GRIFFIN FUNERAL HOME JSP17-13

Public hearing at the request of Novi Funeral Home, LLC for Special Land Use Permit, Preliminary Site Plan, and Stormwater Management Plan Approval. The subject property is located in section 20, at the southwest corner of Eleven Mile Road and Beck Road and is zoned RA (Residential Acreage). The applicant is proposing to construct a 13,000 sq. ft. building, 98 parking spaces, 23 landbank parking spaces, and associated site improvements for use as a funeral home. A special land use is required for a non-residential use in a residential zoned property.

Planning Review GRIFFIN FUNERAL HOME

Preliminary Site Plan and Special Land Use

DATE: 2-16-17 SCALE: HOR. 1" = 30'
 DESIGNED BY: JAW JOB NO.: 16121
 DRAWN BY: JAW SHEET: C-2

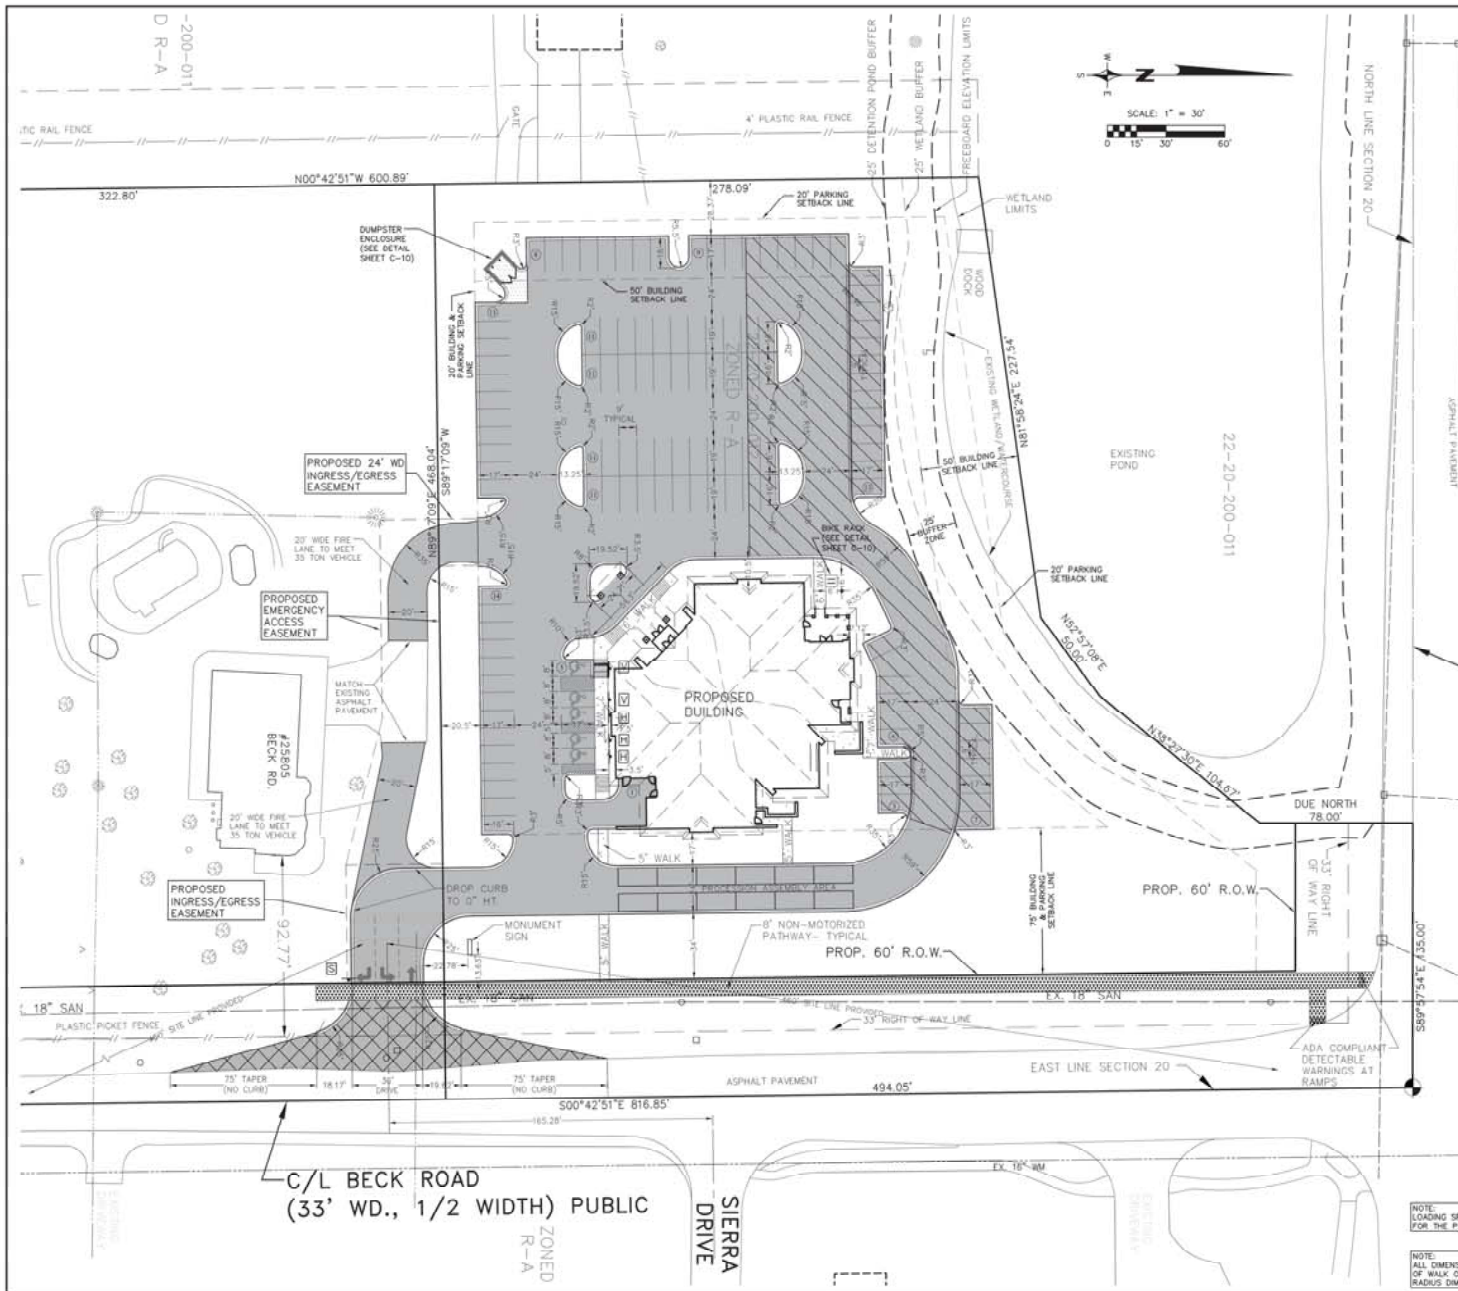
1. All trees in the vicinity of the project are shown as being removed or saved.
2. No trees protected under Section 37 are shown to be removed so no replacement trees are required.
3. **Please add tree protection fencing to Sheet C-2 for trees within 50 feet of the project that will be saved so they aren't damaged during construction.**

1. Noted.
2. Noted.
3. Tree protection will be added to civil drawing C-2 per requirement.
